**Docket No.: 200311928-1**

In re Application of	:	
	:	
Charles R. Weirauch	:	Confirmation No. 4096
	:	
U.S. Patent Application No. 10/618,115	:	Group Art Unit: 2627
	:	
Filed: July 10, 2003	:	Examiner: Tawfik A. Goma

For: OPTICAL STORAGE MEDIUM WITH OPTICALLY DETECTABLE MARKS

**AMENDMENT** UNDER 37 C.F.R. 1.111

FIG. 6

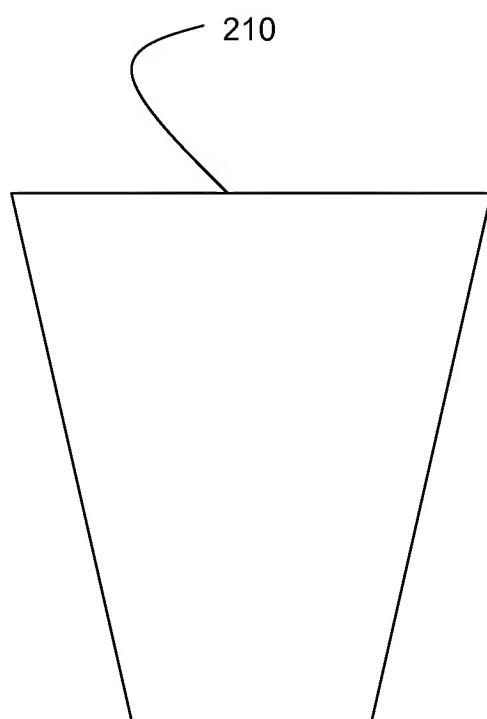
Please add the attached drawing, FIG. 6.

Fig. 6 is an illustration showing a trapezoidal shaped optically detectable mark according to an embodiment.

A new drawing is being submitted herewith reflecting a trapezoidal shaped mark 210. Support for the drawing is found at at least page 7, line 8 of the instant specification. The specification is being amended to reflect the addition of new FIG. 6.

The objection to the drawings is believed overcome in view of the foregoing drawing amendment. Withdrawal of the objection is respectfully requested.
